**UNITED STATES ENVIRONMENTAL PROTECTION AGENCY
REGION III
841 Chestnut Building
Philadelphia, Pennsylvania 19107-4431**

R : Naval Air Warfare Center (NAWC)

Please find below EPA comments on the Phase III RI Workplan for NAWC dated January 1995 as it applies to the soil gas survey for Area A and the footprint of OU-1 construction within Area A.

Enclosure 1
 (to letter of March 2, 1995)

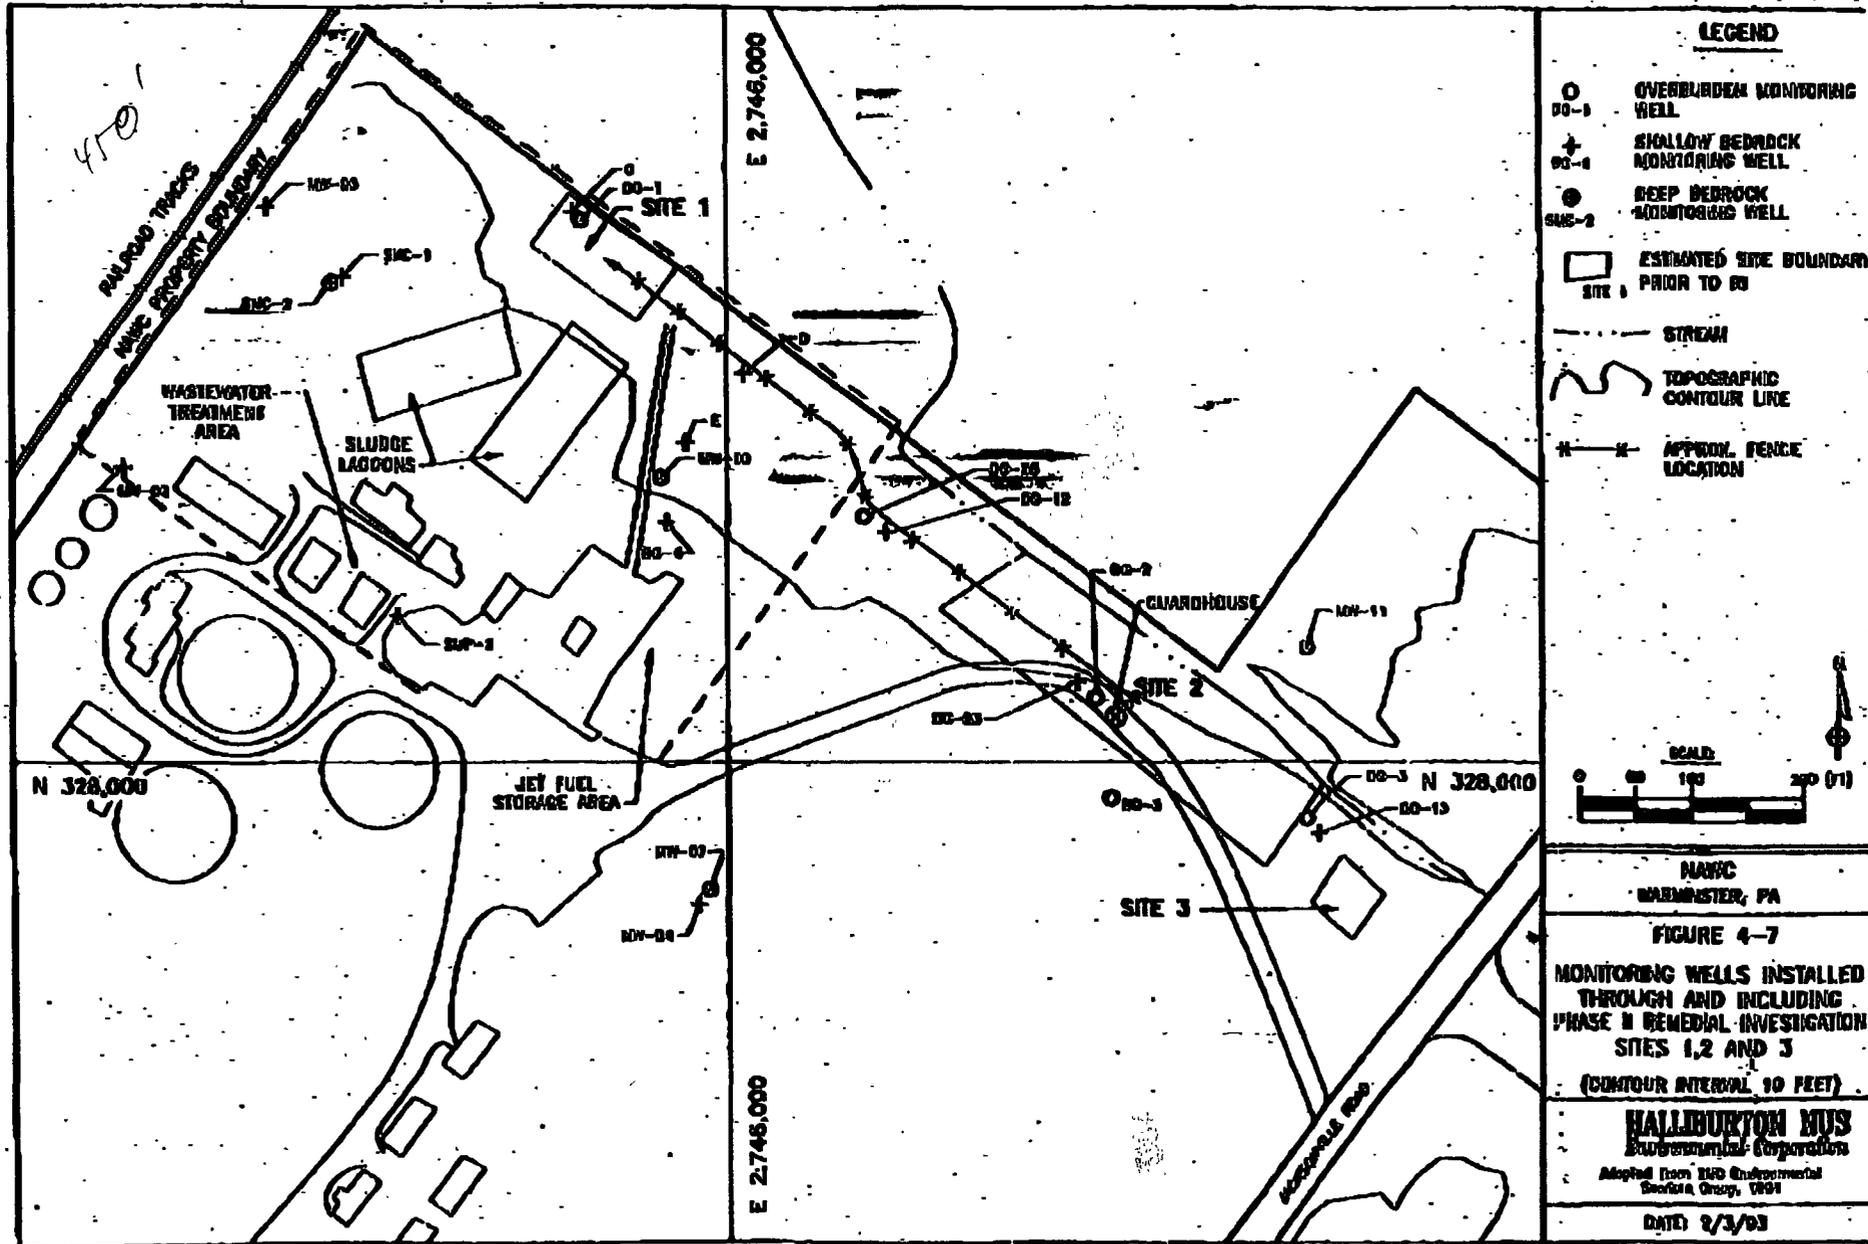
- 1. The aerial extent of soil gas survey should be expanded to encompass the area of the Industrial Wastewater Treatment Plant (IWWTP) and the jet fuel storage area, and should include the areas of Well SMP-2 (PCE detected at 130 ug/l) and RCRA Well D (PCE detected at 220 ug/l). (See Enclosure 1 for a map indicating the requested aerial extent of the soil gas survey in the IWWTP and jet fuel storage area. The eastern perimeter of this area is estimated. The actual eastern perimeter of this area should be sufficient to detect any releases from the jet fuel storage area.) The soil gas sample grid in this area should extend over the two current concrete impoundments and include the collection of soil gas samples under these two impoundments.**

--- Boundary of aerial extent of soil gas survey
 in INWTP and fuel storage area
